CERTIFICATE OF APPROPRIATENESS PLACARD

405 N EAST STREET

095-14-MW

Raleigh Historic Development Commission – Certificate of Appropriateness (COA) Application

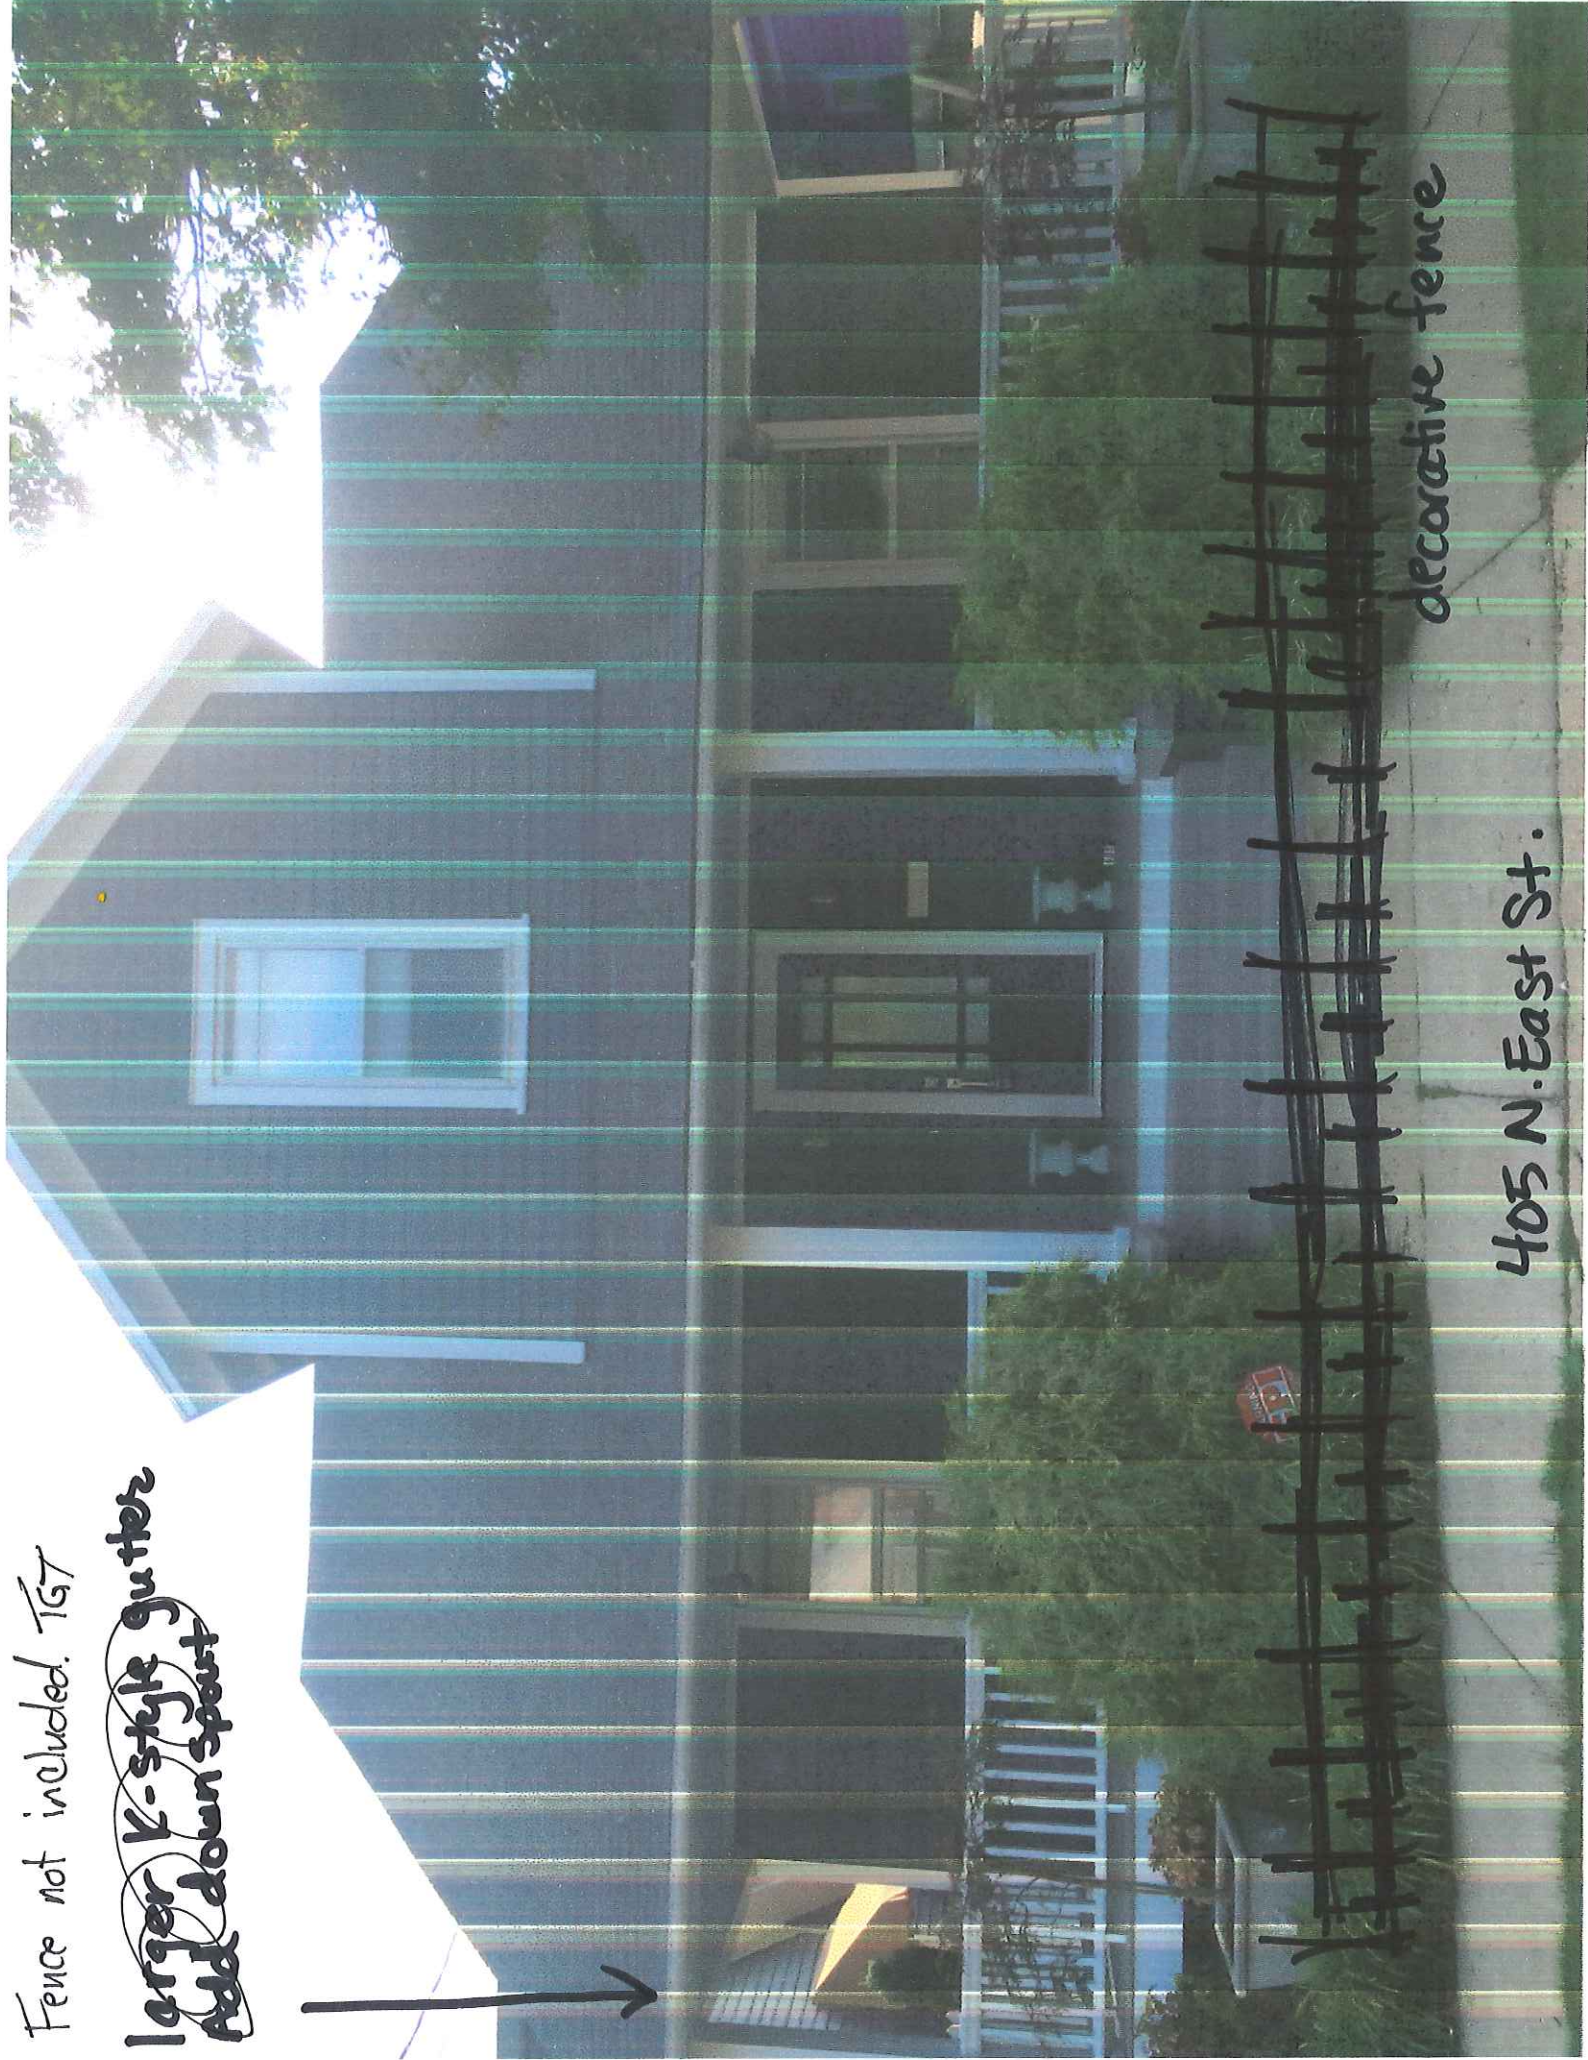
Fence not included. T&T

larger K-style gutters
add down spout

decorative fence

405 N. East St.

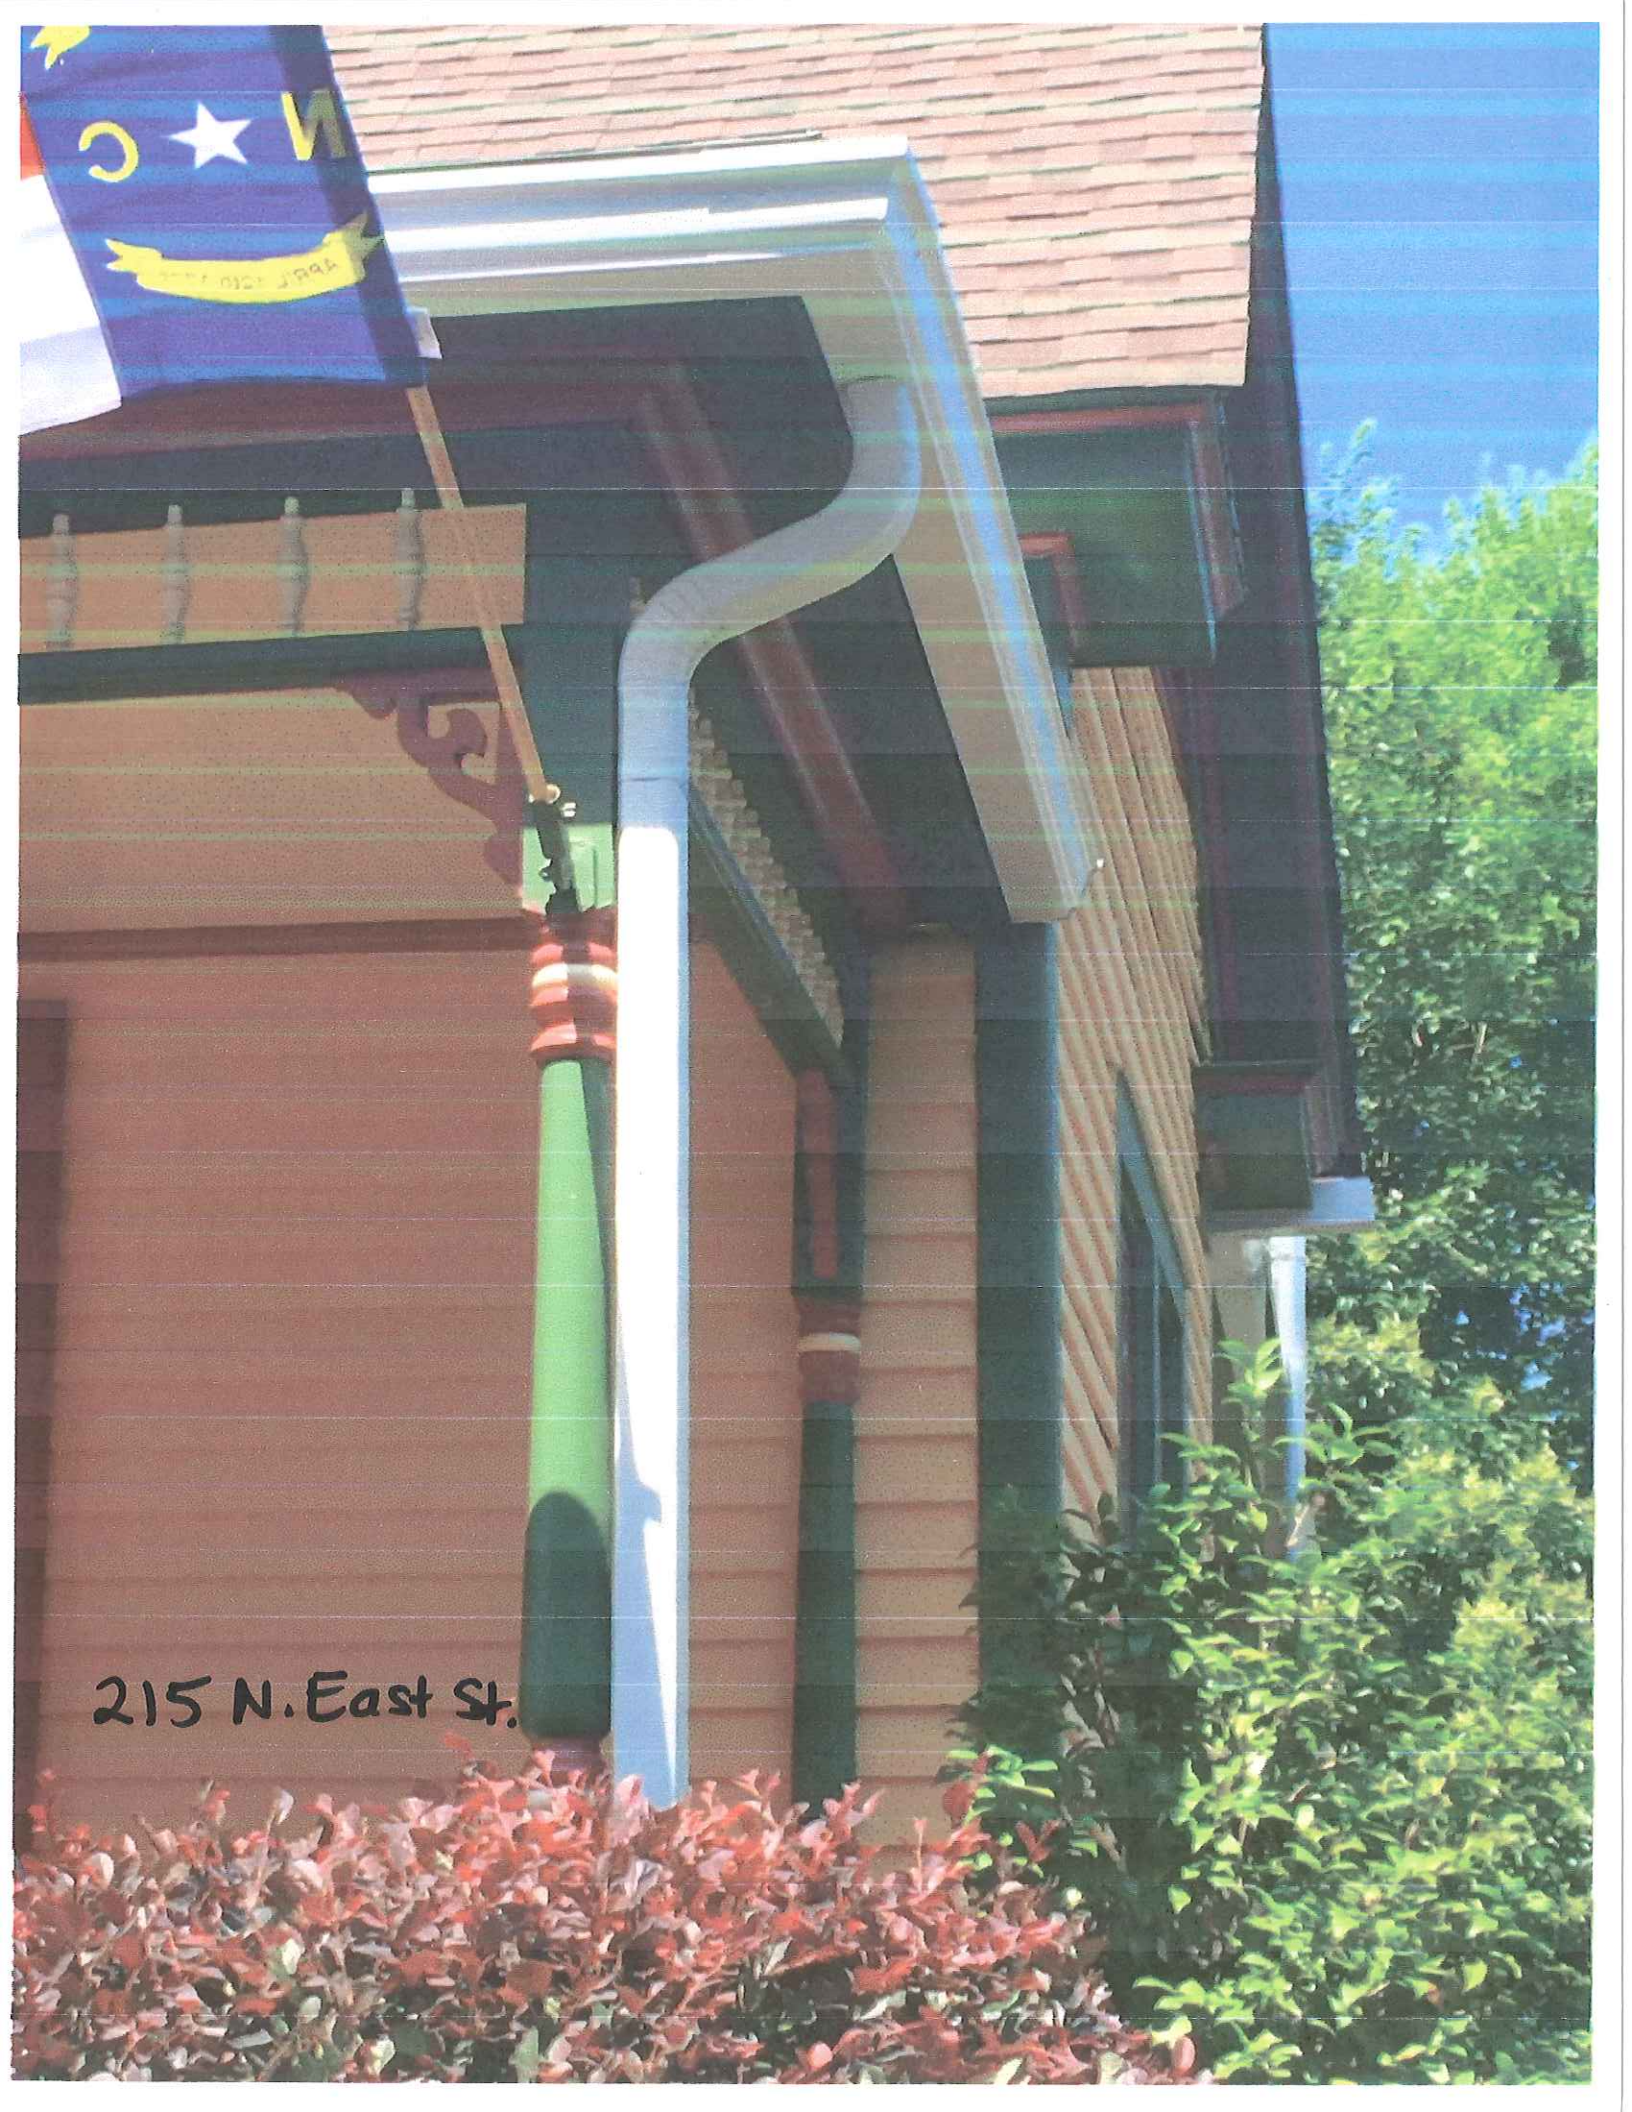
3.5.8 My new porch was restored from foundation to floor, but now the gutters have been flooding the new porch. I have had my contractor make multiple attempts to repair the existing gutters, but it has not worked. After speaking with Tim Bradley, he stated the half rounds are too unstable on my type of roof-line, I need an additional downspout added to the left side of the house, and the gutters need to be large K-style to handle to amount of water that runs off my roof pitch. The gutters will be the same as 215 N. East Street, but the downspouts will be round like the ones that are currently on my house.

6" K-style white aluminum with 4" round non-corrugated white downspouts.
